**BELLEFONTE COMBINED LICENSE APPLICATION – RESPONSE TO REQUEST FOR
ADDITIONAL INFORMATION – REGIONAL CLIMATOLOGY**

Reference: Letter from Joseph M. Sebrosky (NRC) to Andrea L. Sterdis (TVA), Request
for Additional Information Letter No. 022 Related to SRP Section 02.03.01
for the Bellefonte Units 3 and 4 Combined License Application, dated
May 20, 2008.

Subject: Regional Climatology in the Final Safety Analysis Report

Jackson County Census Block Groups

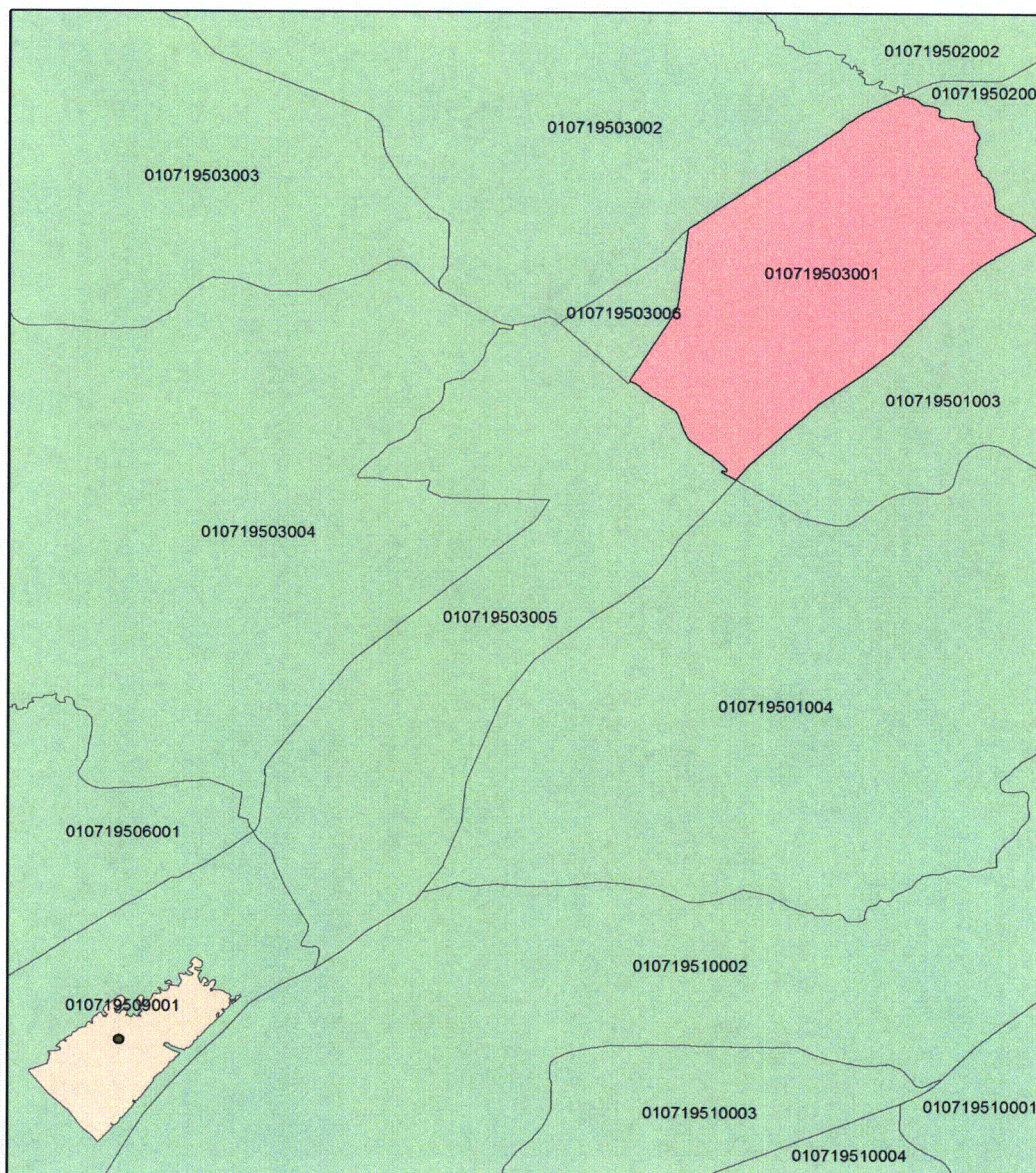
The BLN FSAR identified the Air Quality Control Region (AQCR) for Jackson County as part of the Tennessee River Valley (Alabama)-Cumberland Mountains (Tennessee) Interstate Air Quality Control Region. Attainment designations were provided, and a nonattainment for PM-2.5 (particulate matter with a diameter less than 2.5 microns) was identified for Jackson County. Please describe any impact that the nonattainment area designation has on the design and/or operation of the proposed nuclear power unit.

The nearest non-attainment area is in Walker County, Alabama in an area described by U.S. Census 2000 block group identifiers 01-127-0214-5, 01-127-0215-4, and 01-127-0216-2. This area is approximately 14 miles north east of the site as shown on the enclosed map. The design and/or operation of the BLN units will not be impacted by this nonattainment area due to the distance between the nonattainment area and the site. Likewise, the operation of the proposed nuclear power plants will have no impact on this nonattainment area due to the very low particulate matter release from BLN. A map with the highlighted nonattainment area is provided on the next page of this response.
